Project: **Moorfield Care Home**
388 Tottington Road, Bury, BL8 1TU

Title: **Proposed Site Plan**

Drawing Number: **SI-XX-DR-A-1002** REV **F**

Proposed Site Plan

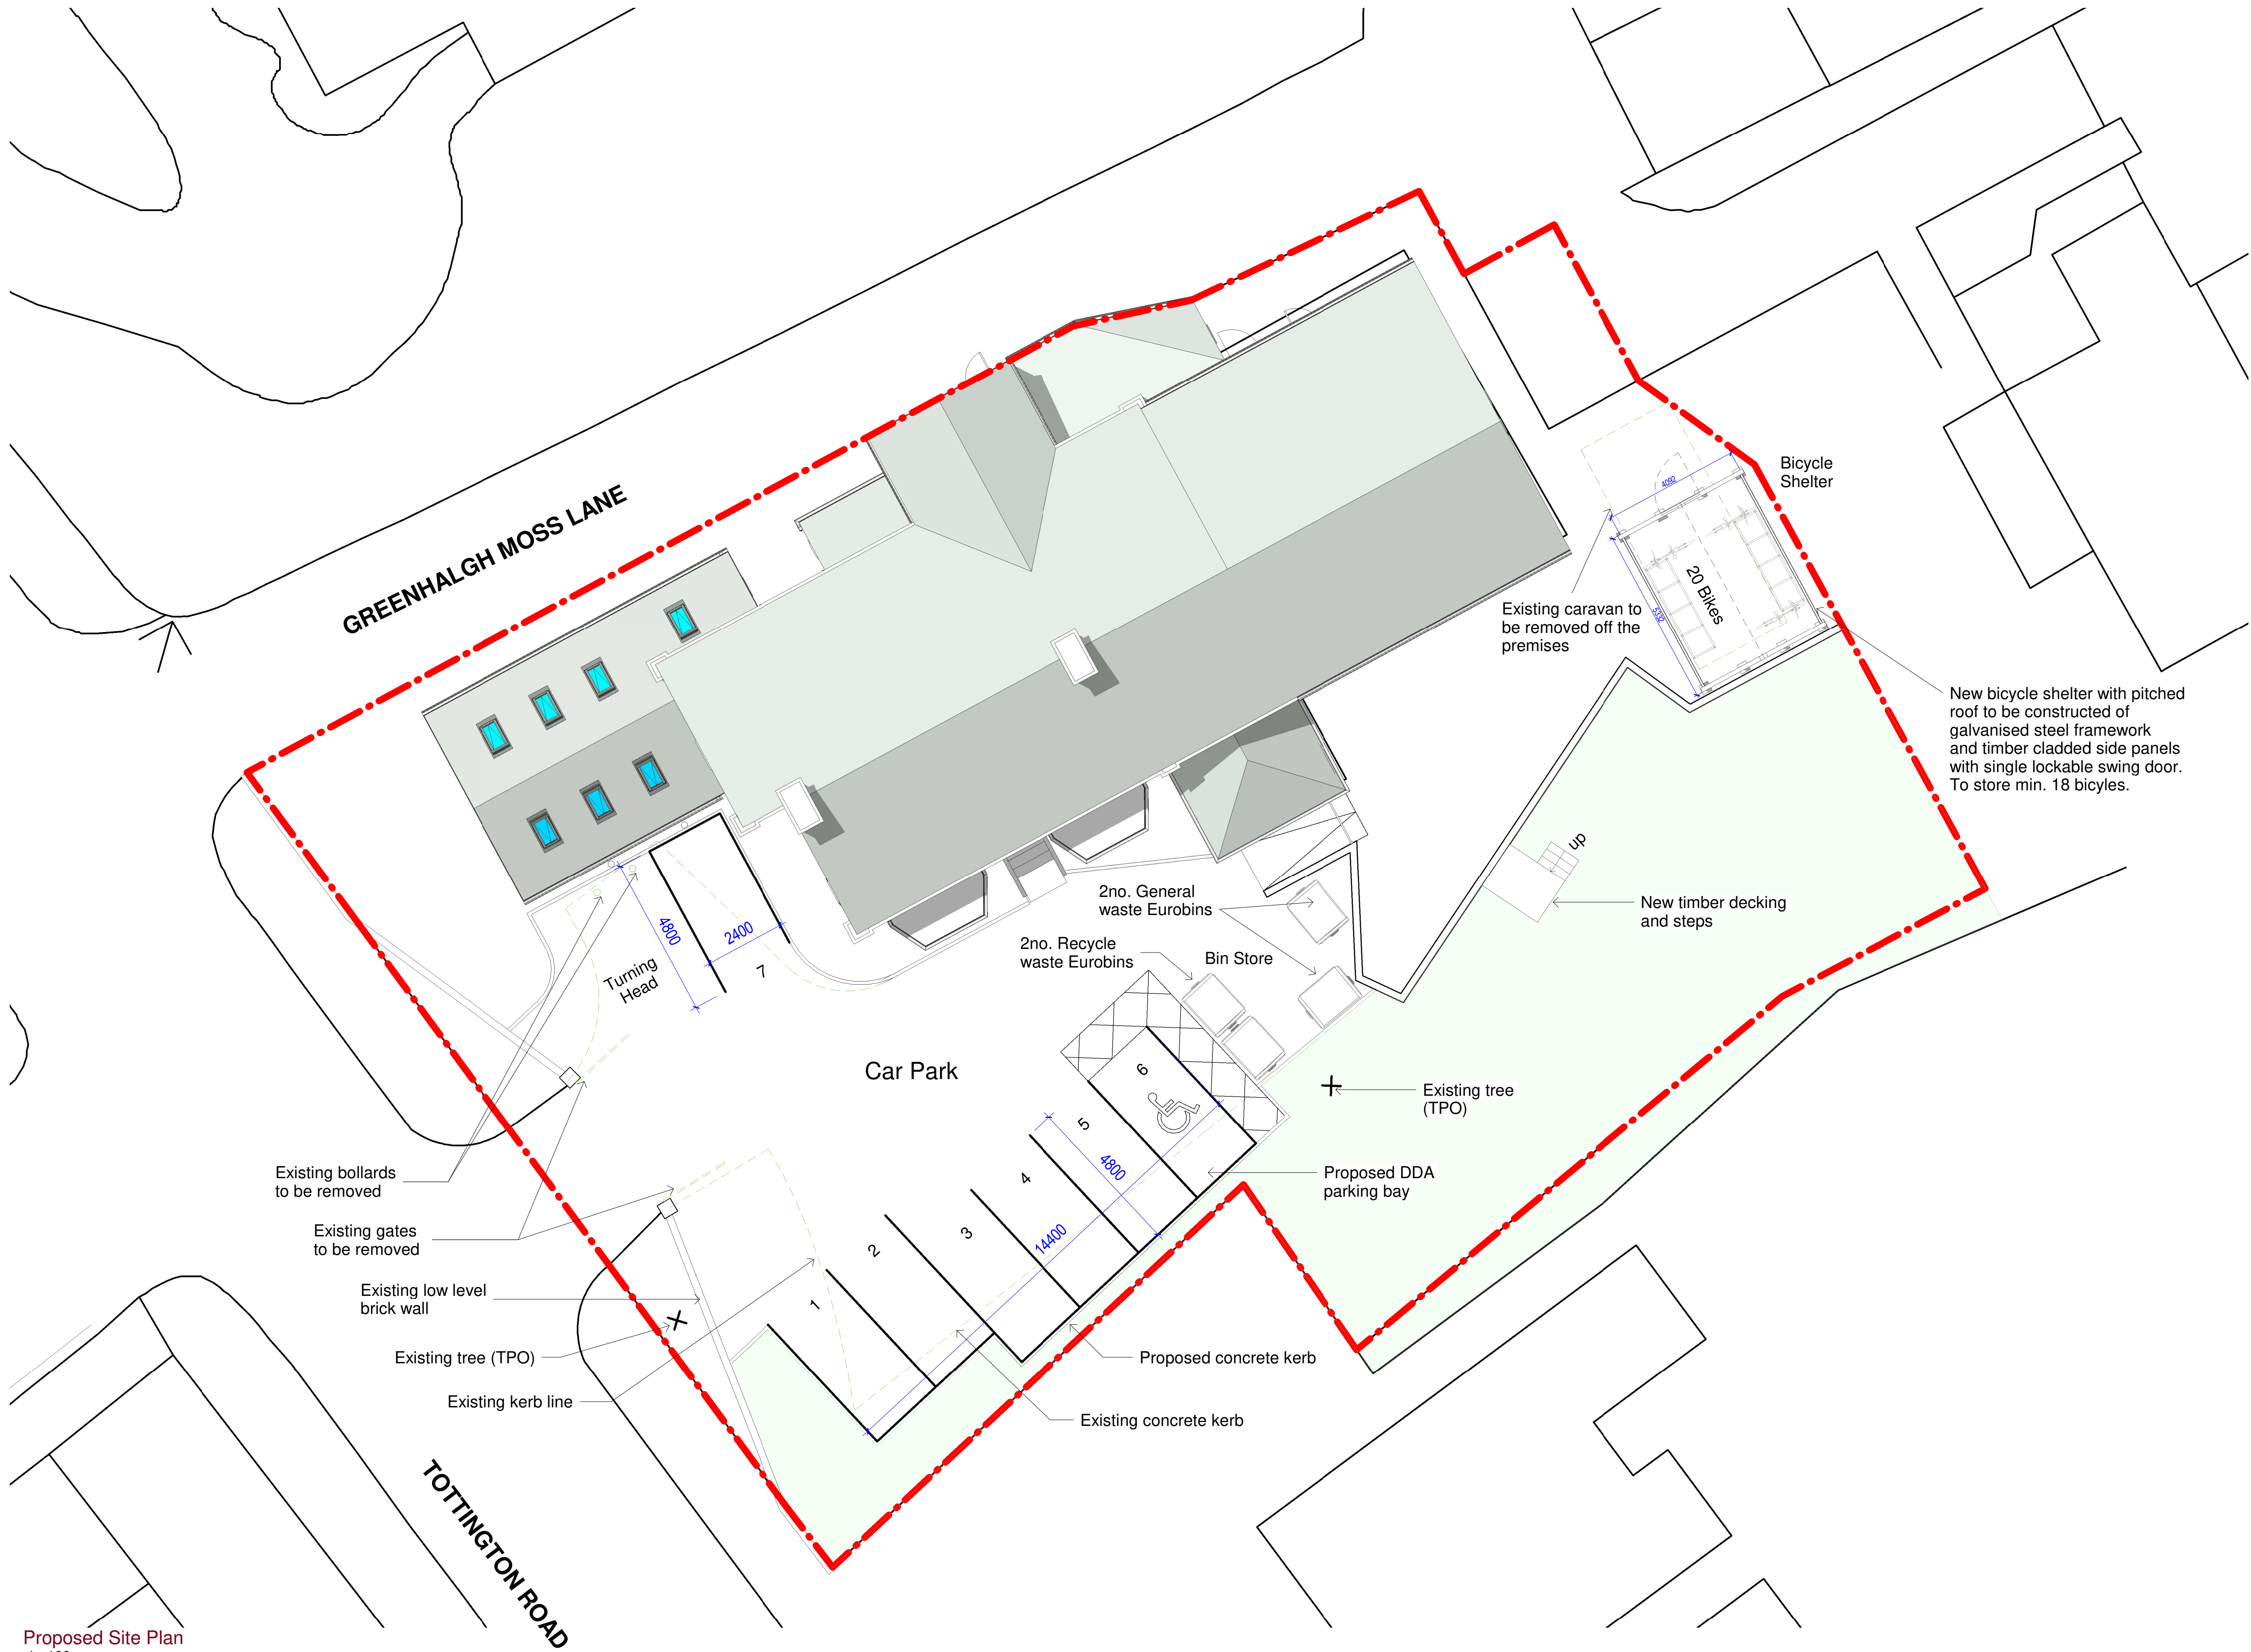
F	Bin store and bicycle shelter relocated in response to planners' comments.	AL	TR	26.02.2024
E	Existing tree next to parking bay 1 deleted to reflect current site layout.	AL	TR	05.02.2024
D	Existing gates removed and "Turning Head" annotation added.	AL	TR	02.02.2024
C	Existing caravan removed and proposed car park layout revised.	AL	TR	18.01.2024
Rev	Description	By	Chk	Date
